HYDROLOGY K23/D7 2 PLANS

Reference: City View Estates Construction Plans

Re: Drainage Plan
City View Estates- Unit "B"

CITY VIEW ESTATES
UNIT "B"
ALBUQUERQUE, NEW MEXICO

Typ. Section – Copper Avenue Channel

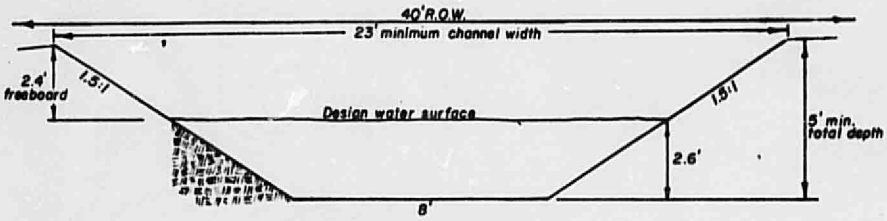
Since I was absent at the time of the review and approval of the plat for the subdivision, I did not have a chance to make comments regarding the hydrology presented in the drainage report. I made three different estimates for the flows carried by the Copper Channel, and all three gave a discharge value twice as great as the one in the report.

Given the existing structure crossing the Copper Avenue Channel at Jewel Place, and an anticipated flow velocity of 26.5 f.p.s., a hydraulic jump will undoubtedly occur, subjecting this development to innundation.

Therefore, I believe that it is mandatory that the crossing structure at Jewel Place be redesigned and constructed, simultaneously with the development, in order to supply the necessary protection.

Further, in the absence of the necessary improvements in the Copper Ave. channel (concrete lining), all the lots along the South boundary line of City View Estates, Unit B, should be withheld from development at this time. Incidentally, I am not aware of the existence of a City accepted final grade and configuration for the Copper Channel; is this grade available? if so, it should be supplied with the plans (these show the 1977 design by Bohannan and Houston which may not be applicable.)

1) The proposed extension of Monte Alto to Copper Avenue will have to be designed as a clear-span trapazoidal structure across the channel section to eliminate any hydraulic jump from occurring upstream from the crossing.

1) We will redesign the structure at the crossing of the Copper Avenue Drainage channel to a clear span trapazoidal section. We are coordinating this with Bohannon-Huston Engrs.

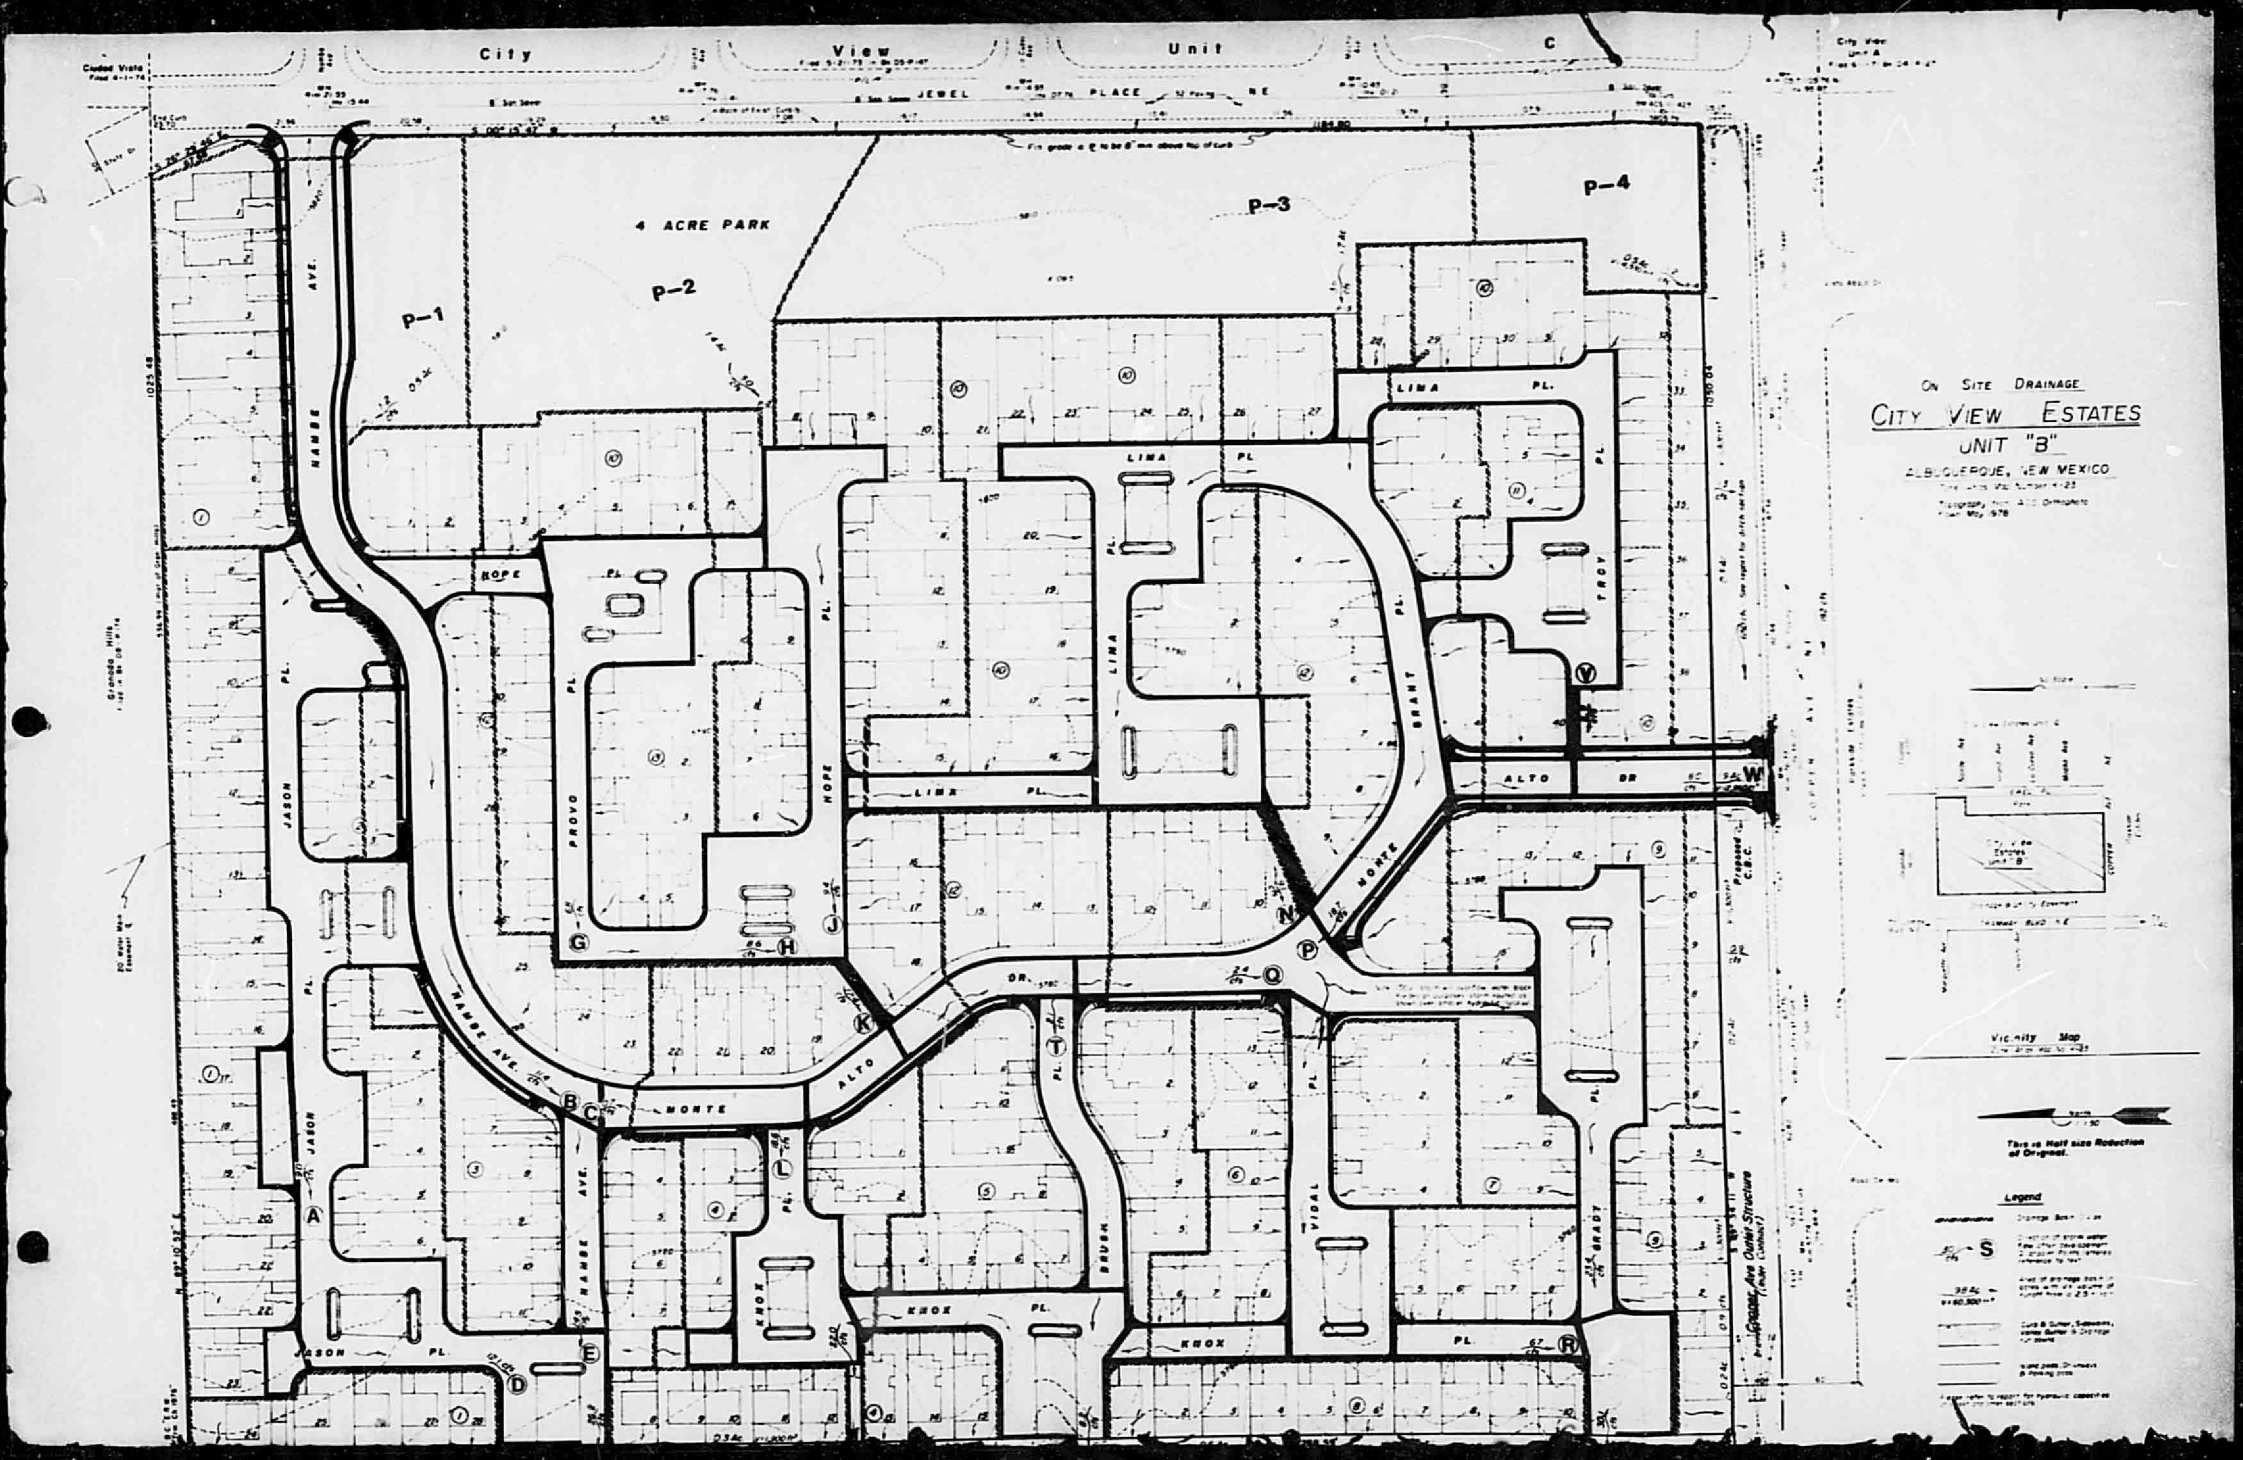
4. The drainage rundown between lots 7 and 8 at the east end of Hope Place is directed toward the driveway of lot 9 on the opposite corner.

5. Can the flow be turned 90 degrees from the rundowns shown between lots 39 and 40 and 18 and 19 on Monte Alto Drive (Locations "V" and "K" on sheet 2) without jumping the opposite curb?

10. Is the northeast corner of the park a ponding area? Some of the areas along the western border of the park look like they might be ponding areas. How will this affect the adjoining properties?

11. The street grades are very deep. Will the cross flow top the mountable curbs? For instance, at the western end of Knox Place, there is a 4 to 5 ft. drop from the east to the west. The water will have a high velocity. Will this water go over the curb into lots 10, 11 and 12, or at least into the driveways?

4. The drainage rundown between lots 7 & 8 at the east end of Hope Place is directed toward the driveway of lot 9 on the opposite corner.

5. Can the flow be turned 90 degrees from the rundowns shown between lots 39 and 40 and 18 and 19 on Monte Alto Drive (Locations "V" and "K" on Sheet 2) without jumping opposite curb?

10. Is the northeast corner of the park a ponding area? Some of the areas along the western border of the park look like they might be ponding areas. How will this affect the adjoining properties?

11. The street grades are very steep. Will the cross flow top the mountable curbs? For instance, at the western end of Knox Place there is a 4 to 5 ft. drop from the east to the west. The water will have a high velocity. Will the water go over the curb into lots 10, 11 and 12 or at least into the driveways?
